**From:** Dan Murney <d.murney@sfbarpilots.com>  
**Sent:** Thursday, January 6, 2022 4:22 PM  
**To:** John Carlier <portagent@sfbarpilots.com>  
**Cc:** Dan Murney <d.murney@sfbarpilots.com>  
**Subject:** Pilot Boarding Arrangement Deficiency Report - DANAE R -

PILOT BOARDING ARRANGEMENTS DEFICIENCY REPORT

Vessel: DANA E R Master: N. MAKSYM

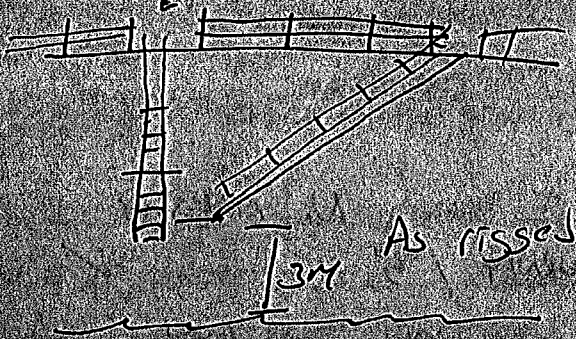
Boarded the Danae R at the pilot station on the even of Jan 5. The accommodation ladder was at 3M above the water with only 2 rungs of pilot ladder below the platform. Fortunately calm seas allowed a boarding with only moderate risk. In a larger swell boarding with this arrangement might not be possible.

REMARKS: (attach photos if possible): Left Vessel arrangement does not permit fore/aft movement of pilot ladder location relative to accommodation ladder. Poor Result was ladder platform @ 3M for boarding off stern. Also poor rigging of stanchions @ sea, corrected for disembarkation.

Fixed location (Needs to be able to move  
alt to allow paper rising)
